SERVICE BULLETIN 00053

Date Released:	February 16, 2022
Date Effective:	February 16, 2022
Subject:	Tailcone Skin Stiffening Clips
Affected Models:	RV-12, RV-12iS
Required Action:	Inspect lower tailcone skin for cracks and install new tailcone stiffener clips
Time of Compliance:	Within 100 hours or at the next 12-month inspection, whichever occurs first
Supersedes Notice:	N/A
Labor Required / SLSA Warranty Allowance:	2.4 hours
Level of Certification:	SLSA: LSA Repairman Maintenance or A&P ELSA: Owner (certification not required) <i>Check the rules of the local controlling authority/agency and the operating limitations for your aircraft.</i>

Figure 2 - Example Crack in Skin

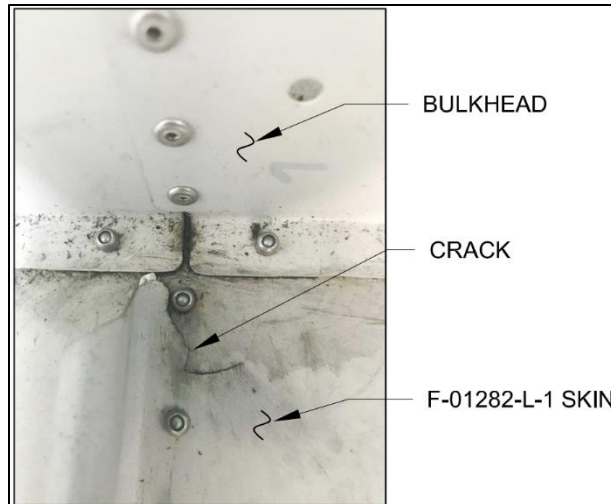
NOTE: Cracks have occurred along the line of rivets connecting the F-01282-L/R-1 Skins.

Step 5: Inspect the lower fuselage skin for cracks near the F-1208, F-1209, and F-1210 bulkheads.

Figure 3 - Example Patch Plate Outline

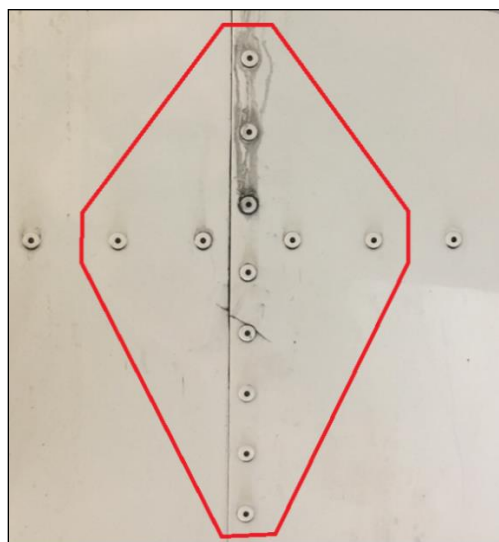
If cracks are found, stop drill the edge of each crack and fabricate a diamond shaped patch like the one shown in Figure 3, below. Fabricate the patch from .032" Aluminum Sheet.

The patch should capture at least three rivets past the crack in the skin or forward and aft of the bulkhead and two rivets left and right of centerline in the bulkhead. Rivets that have a crack within two rivet diameters of the rivet do not count towards the required minimum rivets. The edges of the patch must maintain a minimum edge distance of 2.5 rivet diameters from the center of a rivet to the edge.

Figure 4 - Rivet Removal in Skins

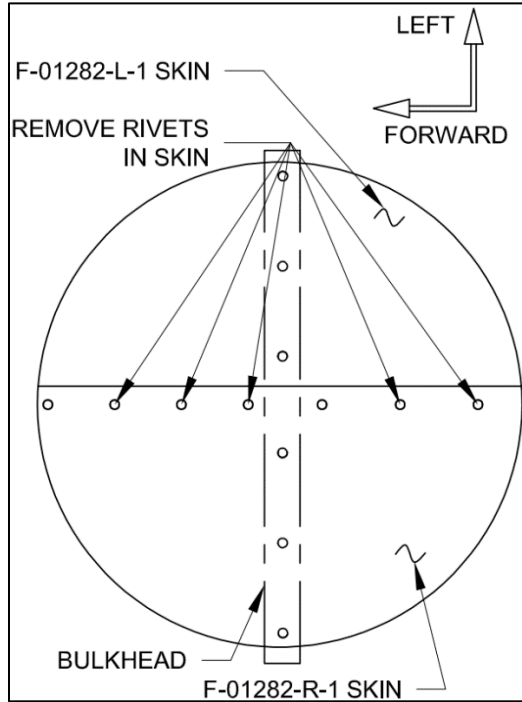
Step 7: Remove rivets in skins as shown in Figure 4 at the F-1208 and F-1209 bulkhead locations. At the F-1210 bulkhead, only remove the three forward rivets depicted in Figure 4.

Figure 5 - Rivet Removal in Bulkheads

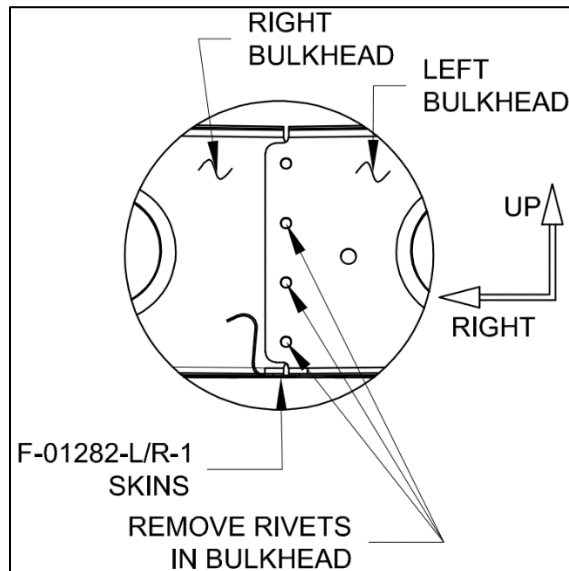
Step 8: Remove rivets in the F-1208, F-1209, and F-1210 bulkheads as shown in Figure 5.

Figure 6 - Forward Clip Installation

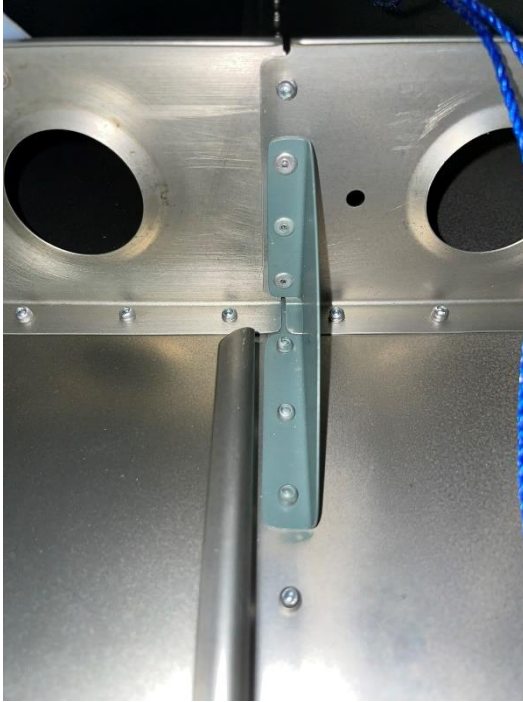
Step 9: Locate the F-12183A and F-12183B clips. These clips will be used on the forward and aft side of the F-1208 bulkhead. Two .063" holes have been punched in the web of F-12183A and F-12183B to help in identification.

Step 10: Rivet the lower hole through the F-12183A, F-1208, and F-12183B using an LP4-3 rivet.

Step 11: Cleco the clips into place and install LP4-3 rivets into the remaining holes.
